## TECHNICAL SERVICE BULLETIN

# Triumph

HEADLAMP PAINT ADHESION

TR7

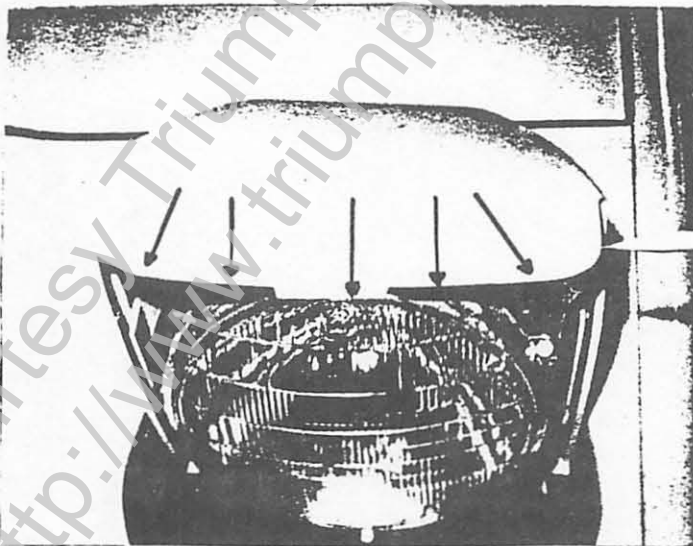
Difficulty has been experienced on early TR7's with the paint flaking along the leading edge of the headlamp assembly (Refer to Diagram).

It is recommended when refinishing this area, to add a radius to leading edge of lamp assembly prior to painting. Please note a time of 1/2 hour per headlamp assembly will be allowed for carrying out this operation.
